Technical Bulletin #2

Sterling B-Vent Spill Switch Correction

Re: Sterling "G" Series, B-Vent Only (Model 8521)

Figure 1: Incorrect

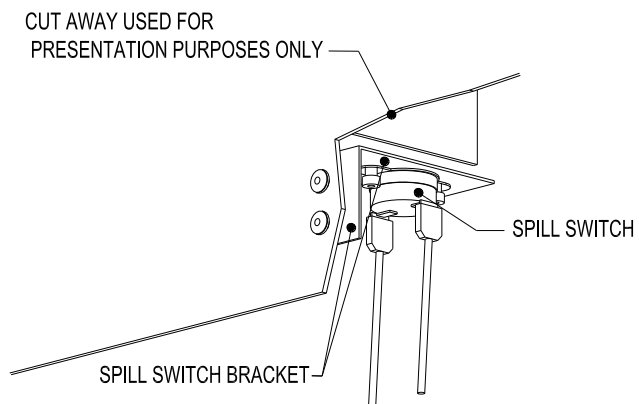
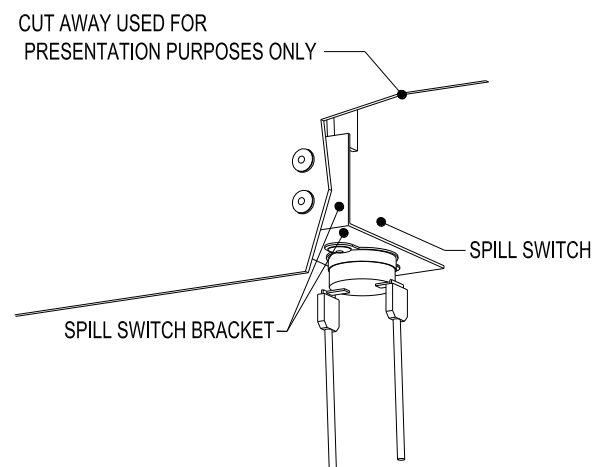
Problem Description: The bracket that holds the spill switch in the draft hood may have been installed upside down at the factory. This would increase the sensitivity of the switch causing the stove to shut down excessively. If you have a customer that reports nuisance shut downs, check to ensure that the spill switch bracket is installed correctly (Figure 2).

The Fix: The bracket is held in place by two "pop" rivets. Using a 1/8" drill bit, drill out the rivets that hold the bracket to the draft hood and the spill switch to the bracket. Turn the bracket over and reattach the spill switch to the bracket and the bracket to the draft hood with new 1/8" pop rivets or with small nuts and bolts with lock washers.
